ISSUE: Permit to Demolish/Capsulate (partial) and Certificate of Appropriateness for alterations

APPLICANT: AB/FH Alexandrian Hotel Owner, LLC

LOCATION: Old and Historic Alexandria District
400 King Street

STAFF RECOMMENDATION

ORIGINAL SUBMISSION

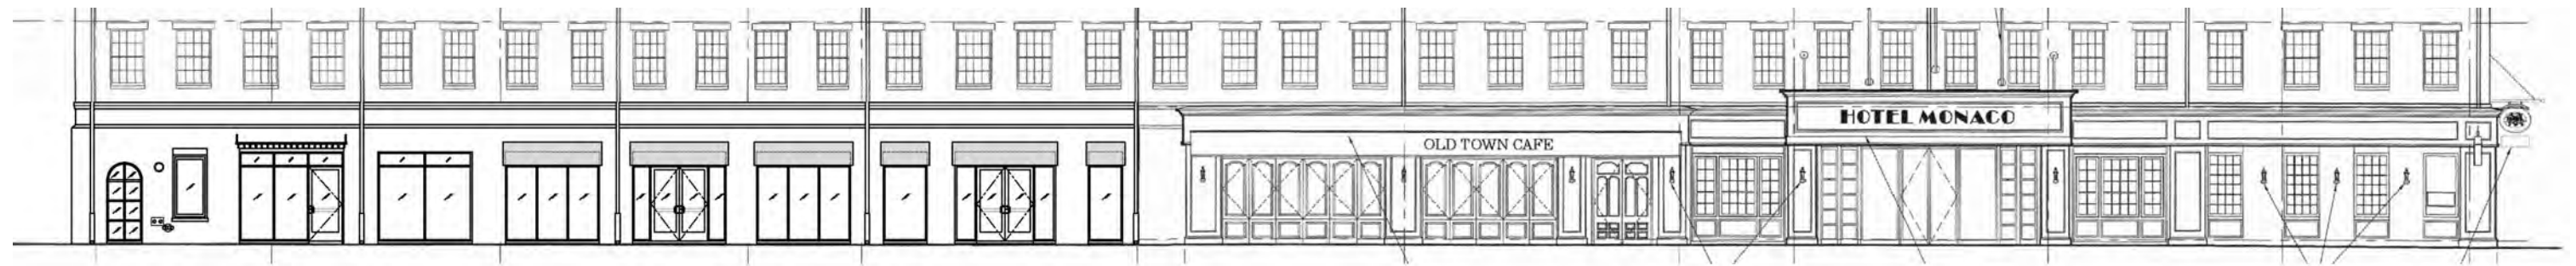
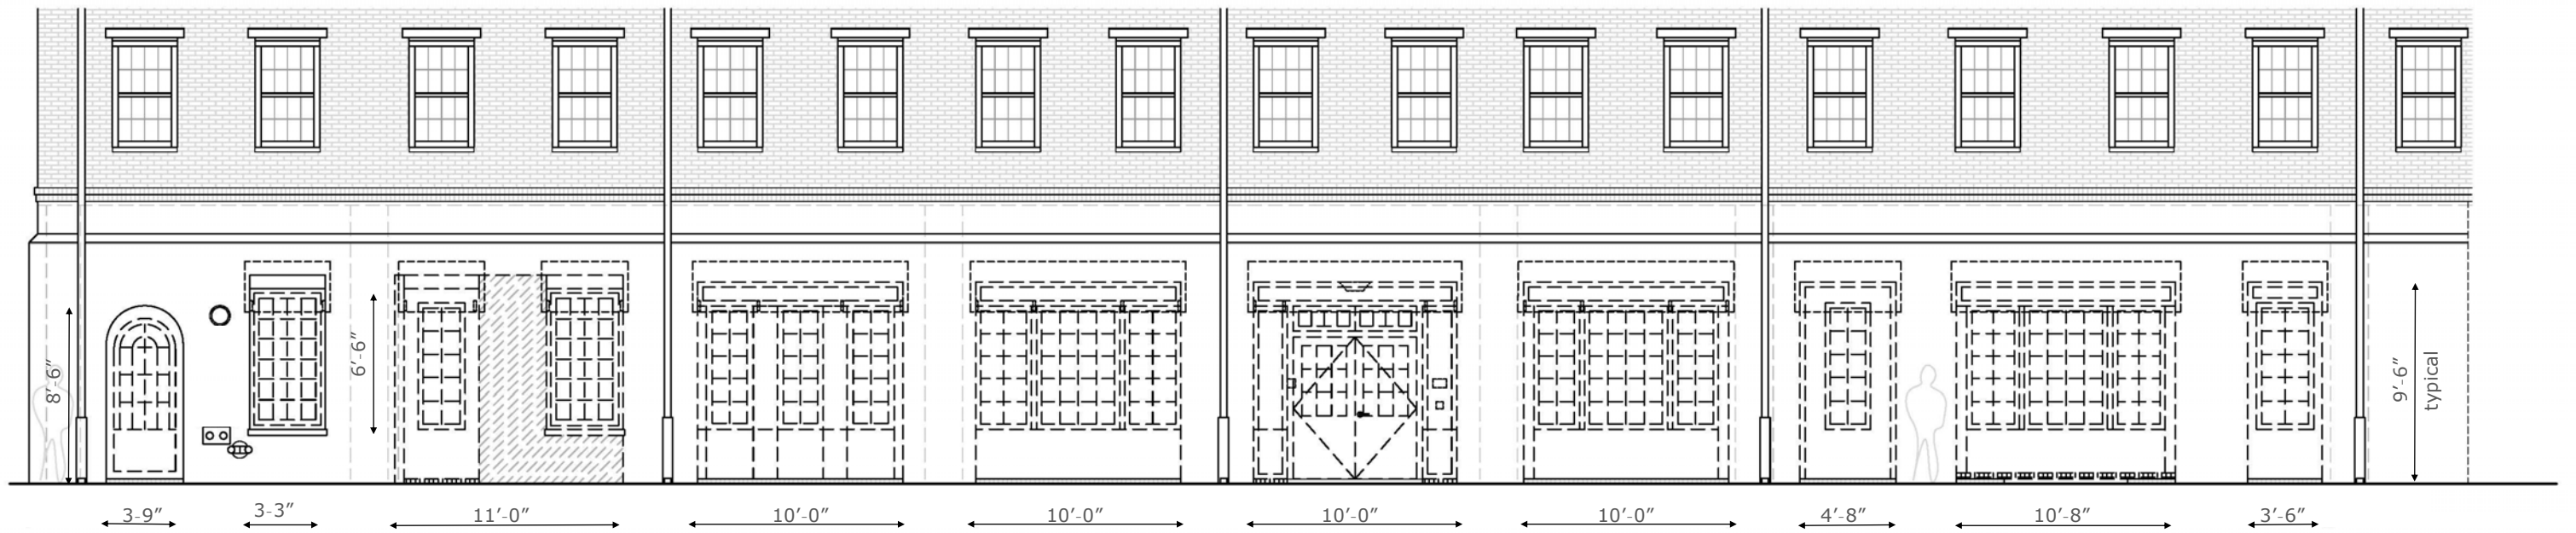
Ms. del Ninno expressed support for ADA entrances and asked for clarification on the proposed ADA entrance. Asked questions about the awning on King St. and the vestibule.

Mr. Scott asked about the type of existing and proposed windows.

Mr. Spencer asked if all the replacement windows will be aluminum.

Ms. del Ninno asked if the applicant investigated insulated windows. She also stated that she supported an alternative window configuration including horizontal elements because it is a retail space.

Mr. Adams original design was to mimic Philadelphia townhouse. Agrees with Ms. del Ninno about the horizontal window elements. Also, he stated that he would prefer the use of wood windows over aluminum and would like to see alternate studies.

Mr. Scott stated that aluminum windows are appropriate for modern buildings and the proposed design should fit in with the rest of the building. He also stated that using wood windows would be appropriate.

Ms. Zandian agrees with staff recommendations and comments from other board members. She also supported the use of wood windows in the new design.

This project is returning to the Board after being deferred at the March 19, 2025, hearing. The updated design addresses the comments of the Board regarding the overall design and how it relates to the existing storefronts. The revised submission no longer includes painting the storefront at the northeast corner of King Street, and the existing awnings will be replaced with a continuous awning at tenant spaces.

The revised submission includes glass storefronts with multi-light configuration and horizontal bands at the base. This updated design is appropriate for the late commercial building and complements the design composition of the existing building. The new design will connect the subject area with the existing tenant space on the northwest corner to create a harmonious first

- MULTI-LIGHT CONFIGURATION SIMILAR TO ADJACENT RESTAURANT
- HORIZONTAL BAND AT BASE SIMILAR TO ORIGINAL WINDOWS AND ADJACENT RESTAURANT AND HOTEL
- DECORATIVE WOOD FRIEZE REALTING TO CORNICE OF ADJACENT RESTAURANT AND HOTEL
- CONTINUOUS AWNING AT TENANT SPACES SIMILAR TO ADJACENT RESTAURANT

2 ELEVATION: KING STREET FACADE - PROPOSED NEW STOREFRONT
SCALE: 1/8"=1'-0"

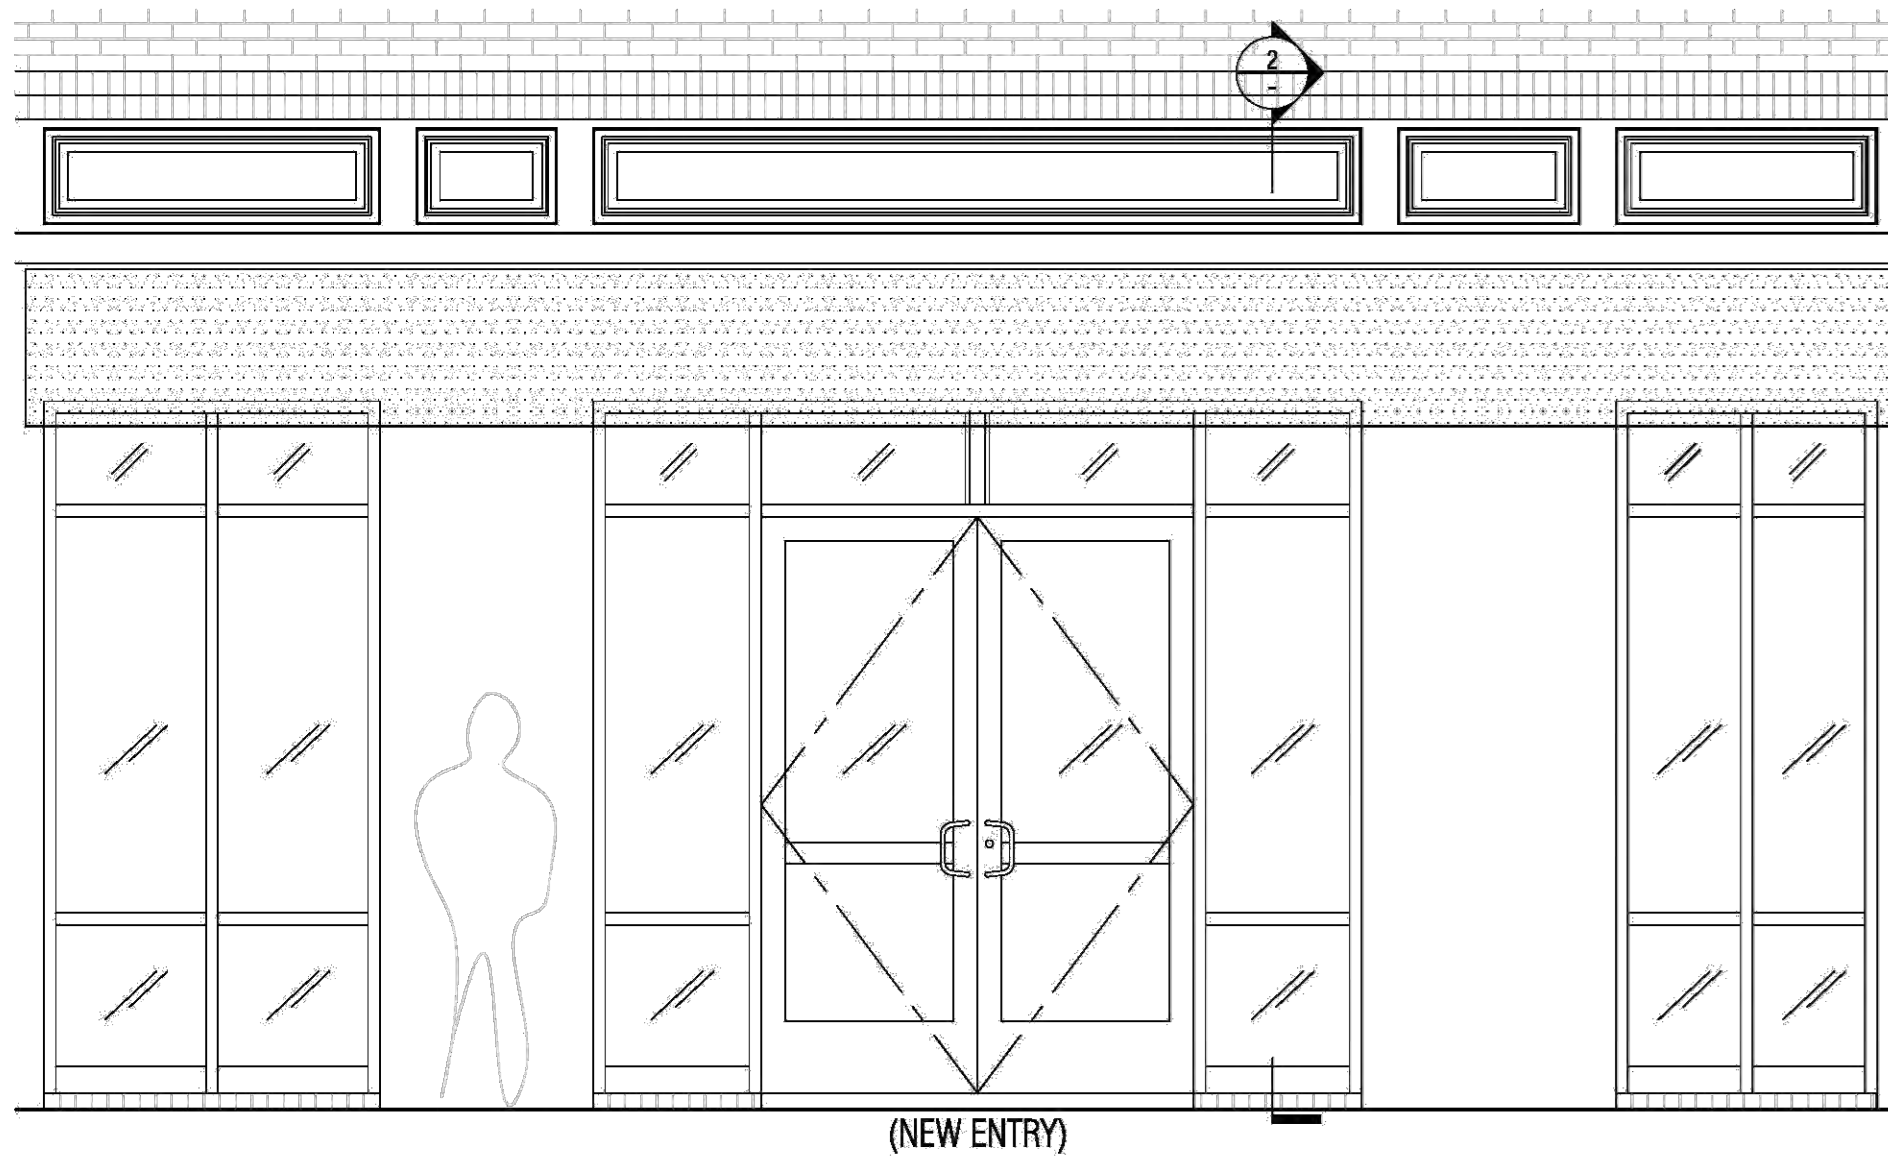
Staff recommends **approval** of the Permit to Demolish/Capsulate (partial), and Certificate of Appropriateness with the condition that the continuous awnings material must be canvas.

The *Design Guidelines* states that awnings should be appropriate and sympathetic to the historical style of the building to which they are attached. The applicant proposes to install a continuous awning at the tenant spaces that are similar to the adjacent restaurant. Staff supports the installation of the continuous awnings, noting that the *Design Guidelines* requires awnings to be made of canvas. Additionally, staff supports the installation of the decorative wood frieze board, noting that it is architecturally appropriate and ties the future tenant spaces with the existing spaces on the northwest corner.
